UNITED STATES PATENT AND TRADEMARK OFFICE

APPLICATION NO.	FILING DATE	FIRST NAMED INVENTOR	ATTORNEY DOCKET NO.	CONFIRMATION NO.
10/780,190	02/17/2004	Kueun Choi	ChoiKueun	9922

Office Action Summary

DETAILED ACTION

Fig. 12

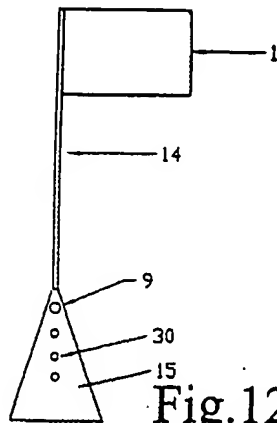
1. The replacement drawing sheet filed 06-30-2005 has not been approved as new Figs. 12 and 13 introduce new matter, namely the plurality of adjustment apertures (30) in Figs. 12, and the adjustment aperture (31) in Fig. 13.

3. The amendment filed 06-30-2005 is objected to under 35 U.S.C. 132(a) because it introduces new matter into the disclosure. 35 U.S.C. 132(a) states that no amendment shall introduce new matter into the disclosure of the invention. The added material, which is not supported by the original disclosure, is as follows: new paragraph [0042] on page 9 of the

substitute specification which is represented in new Figs. 12 and 13. Applicant is required to cancel the new matter in the reply to this Office Action.

DO NOT ENTER W.M. 10/18/05
